# Road Safety Audit for IRR15 AT SR86

## SR 86 & IRR 15 Road Safety Audit

# Visibility of Intersections & Sight Distance

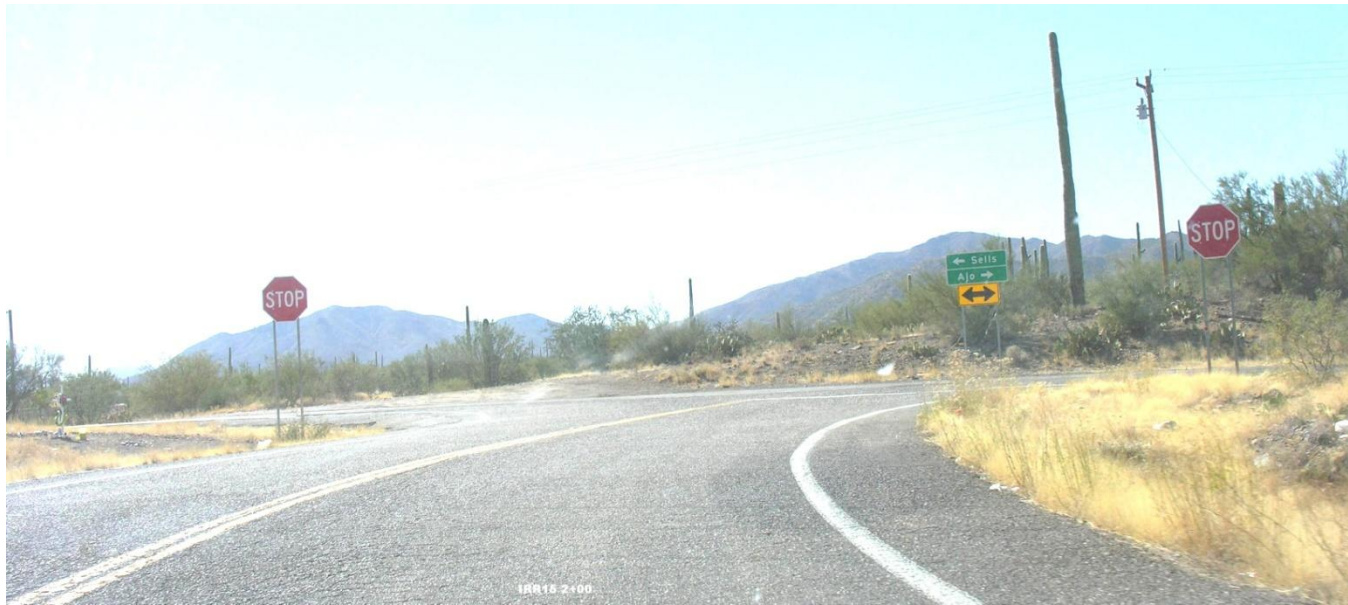
-  Lighting
-  Turn Lanes
-  Cut back slopes on NE & NW Quadrants
-  Remove crest from profile
-  Removal of left side supplemental stop sign to alleviate driver's confusion
-  Transverse rumble strips closer to intersection
